# METROPOLITAN GOVERNMENT OF NASHVILLE AND DAVIDSON COUNTY

## STAFF RECOMMENDATION

628 Shelby Avenue

**Application:** New Construction—Infill

Figure 1. Cantilevered fireplace bay on each side

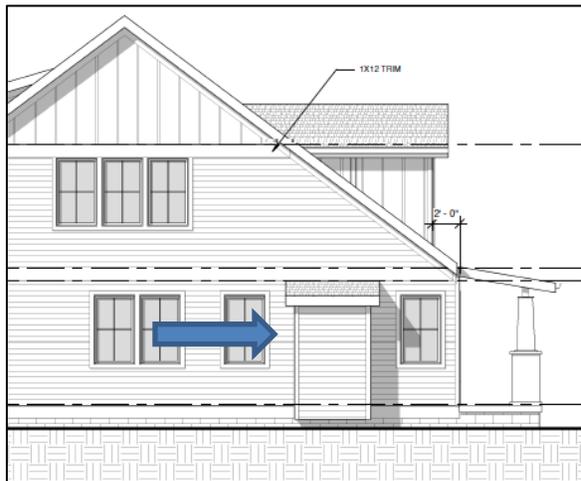
**Height & Scale:** The new building is one and a half stories with a ridge height of thirty feet, three inches (30' 3") from grade. The Commission has approved infill on the same block with heights up to thirty-three feet (33'). The eave height is ten feet, six inches (10' 6") from grade, which is compatible with neighboring buildings which have eave heights from ten to twelve feet (10'-12'). The building is thirty-five feet (35') wide, on a fifty foot (50') wide lot. This is within the range of historic building widths nearby, which are from twenty-five to forty feet (25'-40'). The foundation height is approximately two feet (2'), which is consistent with foundation height of nearby structures, from one to three feet (1'-3'); however, staff recommends that the foundation height be checked in the field to be similar to the historic building to the right. Staff finds that the massing and scale is similar to historic buildings in the neighborhood, and infill that has been approved recently. Each side of the home has a cantilevered bay for a ventless fireplace. In the past, the Commission has required that a similar feature have a foundation. With the condition that the bays have a foundation to grade, staff finds that the project meets sections III.B.2.b. and III.B.2.c. of the design guidelines.

1. The front setback matches the setback of the neighboring house on this block, to be verified on a revised site plan;
2. The bays have a foundation added;
3. The finished floor height shall be consistent with the finished floor heights of the adjacent historic houses, to be verified by MHZC staff in the field;
4. Staff approve the rear porch materials, roofing color, windows and doors prior to purchase and installation; and,
5. HVAC and other utilities shall be located behind the house or on either side, beyond the mid-point of the house.
